INDEPENDENT GEOLOGIST'S NOTES ON BROOKSHIRE SALT DOME

4/11/13

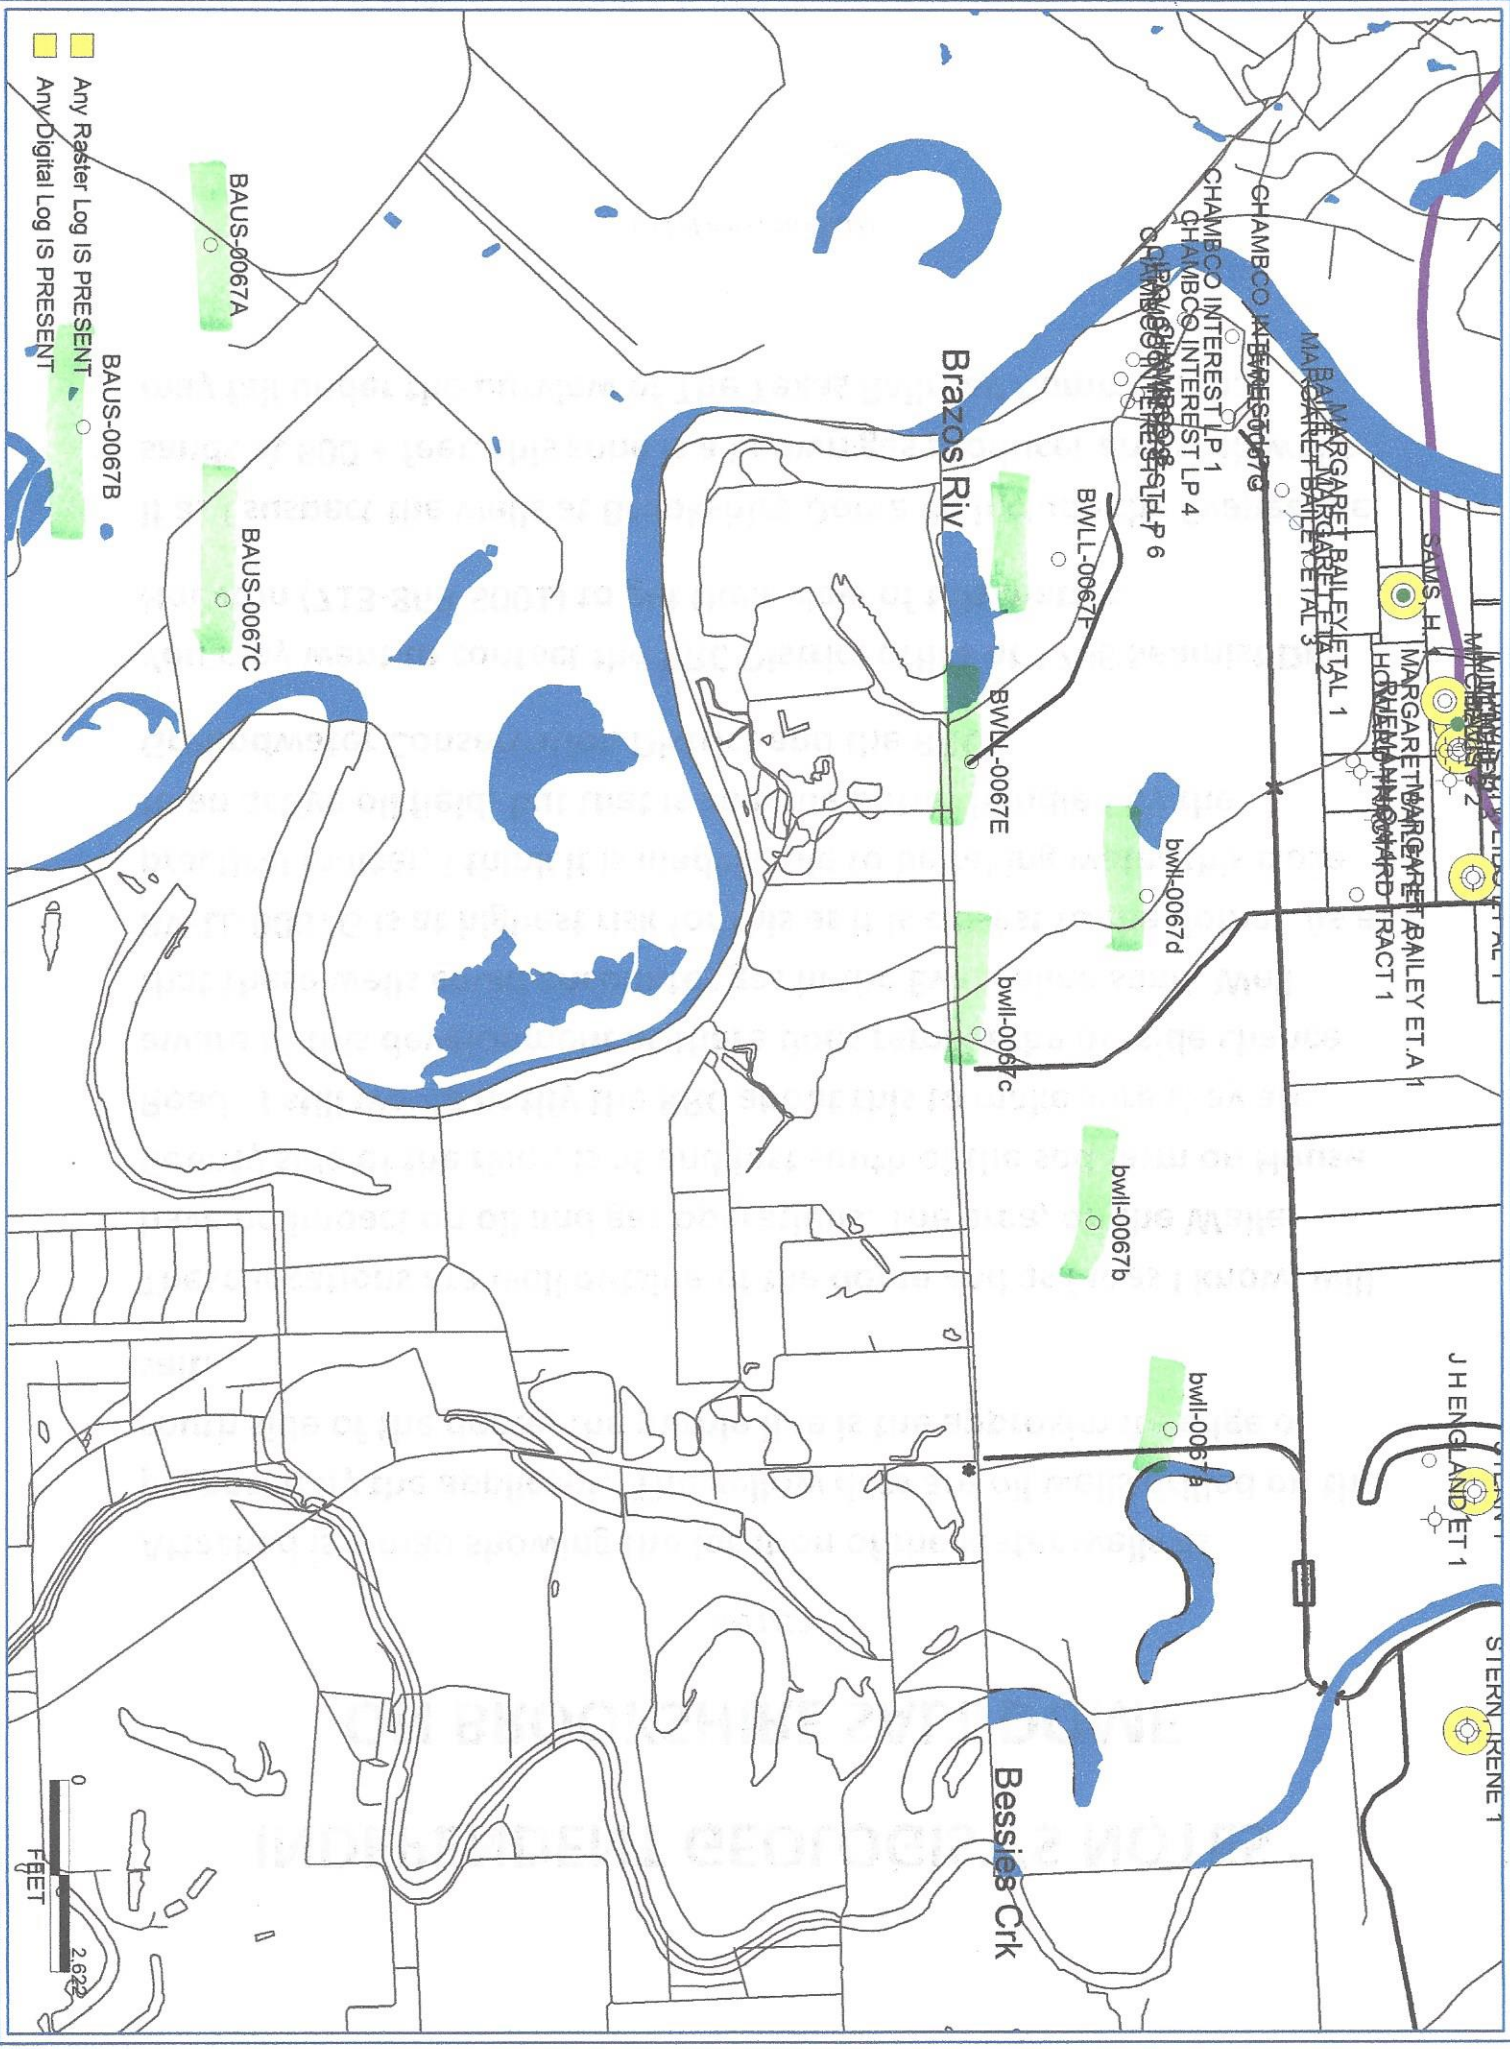
Attached is a map showing the location of the water wells as proposed by the applicant. The yellow dots are oil wells drilled on the south side of the dome, the purple line is the approximate edge of salt.

These locations are well outside of the dome and as far as I know, will have no impact on oil and gas operations. The area, on the Waller County side of the river, is at and just south of the sod farm on House Road. I still would notify the RRC about this to make sure they are aware of this development as there does remain the outside chance that these wells could encounter gas in the Evangeline sand. Well BWLL-0067G is at highest risk for this as it is closest to the dome. As a practical matter, I think it is inadvisable to be taking water this close to an active oil field, but that is an issue better handled by the Groundwater Conservation District and the RRC.
